Work Order ID 120214

Item Name: Screw-In Windshield Modification

A	NEW ISSUE		13.06.20
REV.	DESCRIPTION	BY	DATE
DESIGN		DART AEROSPACE LTD HAWKESBURY, ONTARIO, CANADA	
DRAWN			
CHECKED		DRAWING NO.	REV. A
MFG. APPR.	N/A	DSI 9659	SHEET 1 OF 1
APPROVED		TITLE	SCALE
DE APPR.		SEALANT TAPE	NTS
DATE	13.06.20	COPYRIGHT © 2013 BY DART AEROSPACE LTD. <small>THIS DOCUMENT IS PRIVATE AND CONFIDENTIAL AND IS SUPPLIED ON THE EXPRESS CONDITION THAT IT IS NOT TO BE USED FOR ANY PURPOSE OR COPIED OR COMMUNICATED TO ANY OTHER PERSON WITHOUT WRITTEN PERMISSION FROM DART AEROSPACE LTD.</small>

A	NEW ISSUE	AJS	14.03.18
REV.	DESCRIPTION	BY	DATE
DESIGN	AJS	DART AEROSPACE LTD HAWKESBURY, ONTARIO, CANADA	
DRAWN	AJS		
CHECKED		DRAWING NO.	REV. A
MFG. APPR.	N/A	DSI 9687	SHEET 1 OF 4
APPROVED		TITLE	SCALE
DE APPR.		RETAINER UPGRADE	NTS
DATE	14.03.18	COPYRIGHT © 2014 BY DART AEROSPACE LTD <small>THIS DOCUMENT IS PRIVATE AND CONFIDENTIAL AND IS SUPPLIED ON THE EXPRESS CONDITION THAT IT IS NOT TO BE USED FOR ANY PURPOSE OR COPIED OR COMMUNICATED TO ANY OTHER PERSON WITHOUT WRITTEN PERMISSION FROM DART AEROSPACE LTD.</small>

FIGURE 3-2
(REF IIN-D206-817 REV D)

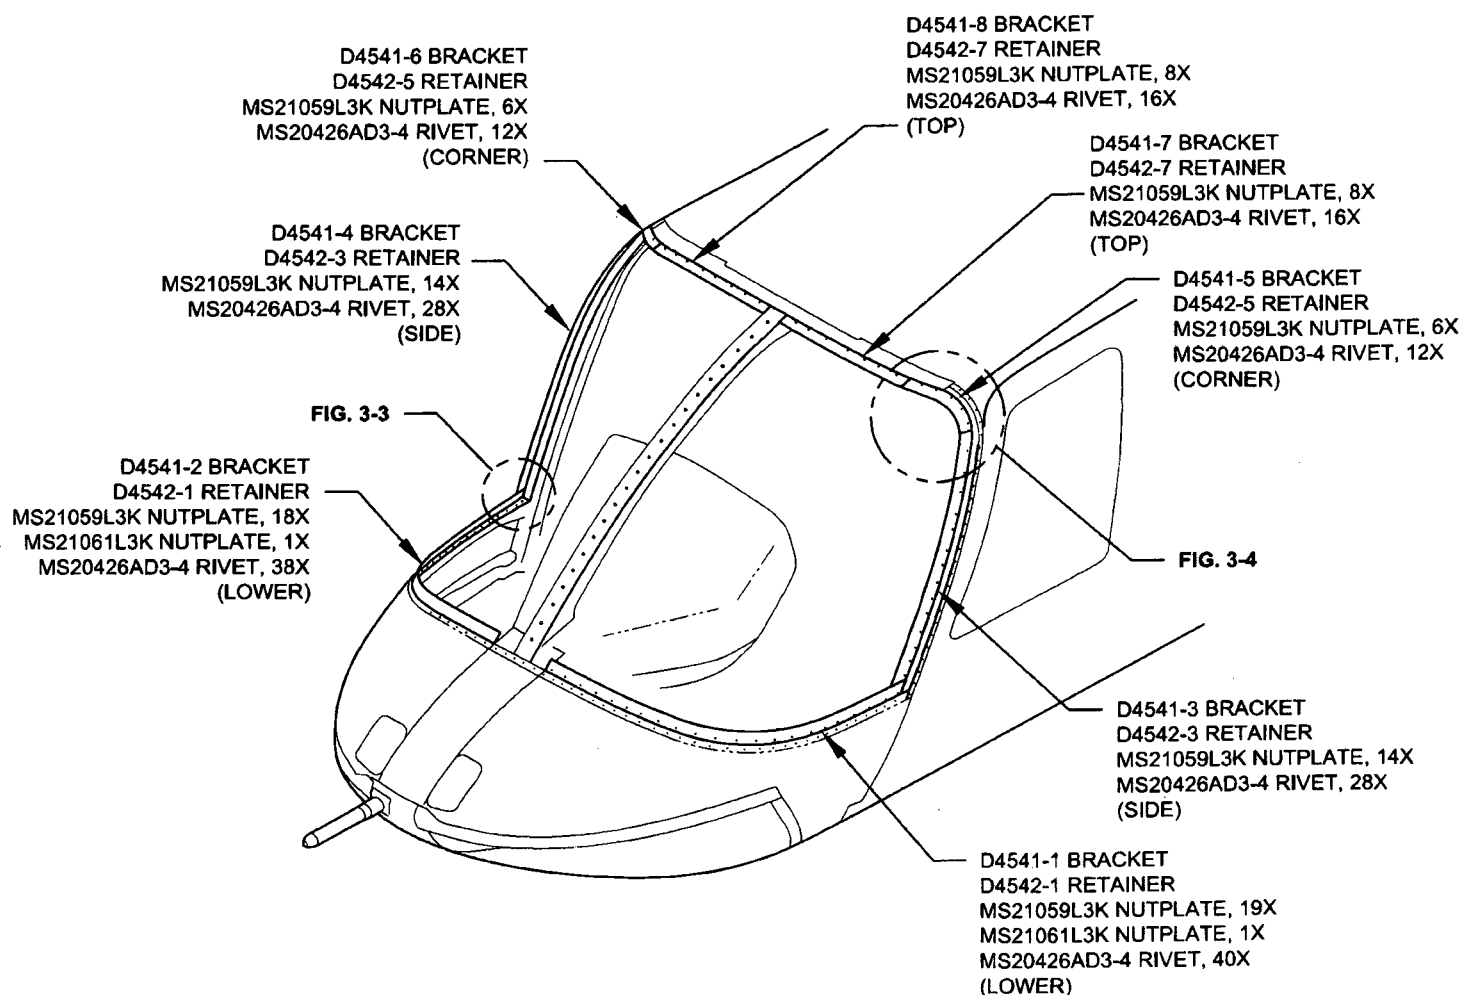
- 3.3 Install Dart inner retainers. It is acceptable to hand form retainers as required to allow fit. Retainers should be located so that they are approximately flush with the aircraft skin. Locate retainers and transfer drill $\varnothing 0.128$ " from aircraft frame. Locate as follows, using Figure 3-2 as reference:

- a) Locate D4541-1/-2 Brackets along the bottom window frame flush against the door pillars. The Bracket should be oriented with the hole pattern for the MS21061L3K nutplate (the non-symmetric nutplate, ref) near the door post. See Figure 3-3 for reference.

FIGURES 3-2 & 3-3 OF INSTALLATION INSTRUCTIONS IIN-D206-817 REV. D ARE MODIFIED AS SHOWN ON SHEETS 3 AND 4 OF THIS SERVICE INSTRUCTION.

FIGURE 3-3
(REF IIN-D206-817 REV D)

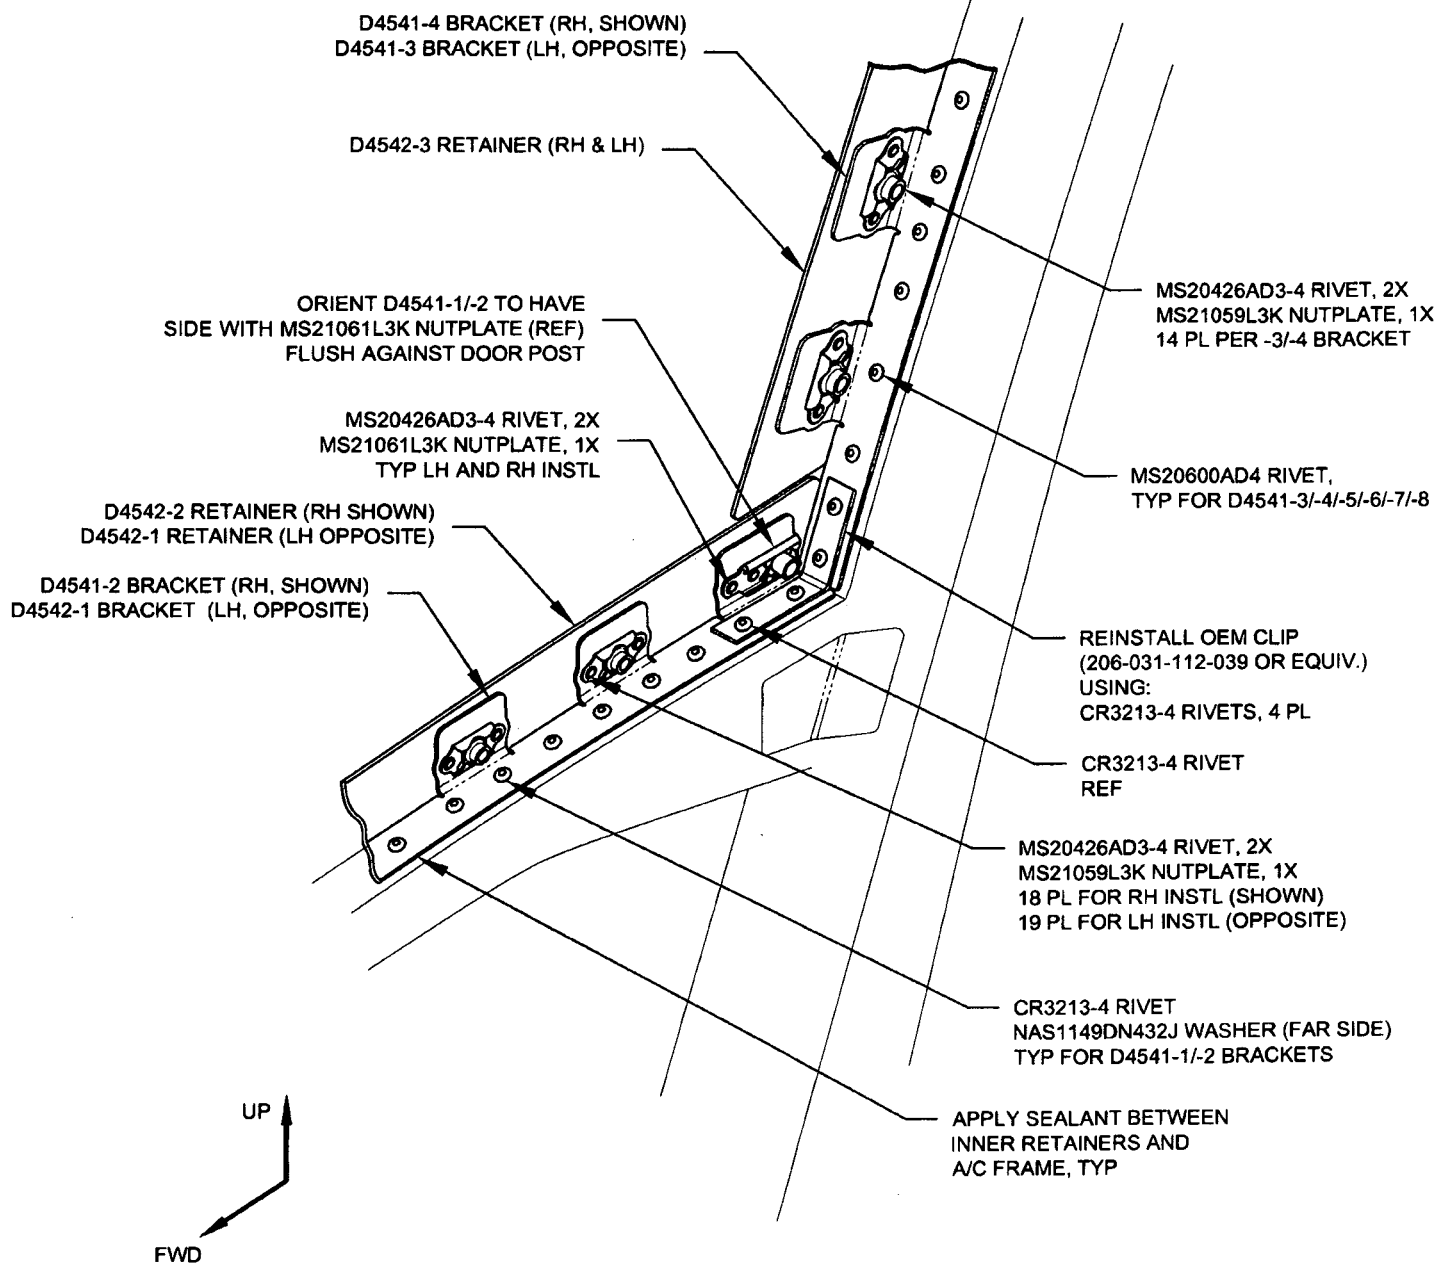
- b) Locate D4541-3/-4 Brackets on the door pillars, above the -1/2 Brackets. See Figure 3-3.
 - c) Locate D4541-5/-6 Brackets above the -3/-4 retainers. See Figure 3-4.

- d) Locate D4541-7/-8 Brackets along the top edge, with one side aligned with the center column. See Figure 3-4.
 - e) Relocate the 206-031-112-039 (or equiv.) clip removed at step 3.2(g) per Figure 3-3.

Install brackets wet with Sikaflex-241/-291 or Proseal 890 or MIL-S-8802 sealant between retainers and a/c frame. Fasten D4541-1/-2 Lower Inner Brackets with CR3214-4 (or NAS9301B or M7885/2) rivets and NAS1149DN432J (or 140-001-1 or AN960JD4 or equiv.) washers. Fasten D4541-X Brackets with MS20600AD4 rivets. Reinstall clip (206-031-112-039 or equiv.) with CR3213-4 rivets. See Figure 3-3 for reference.
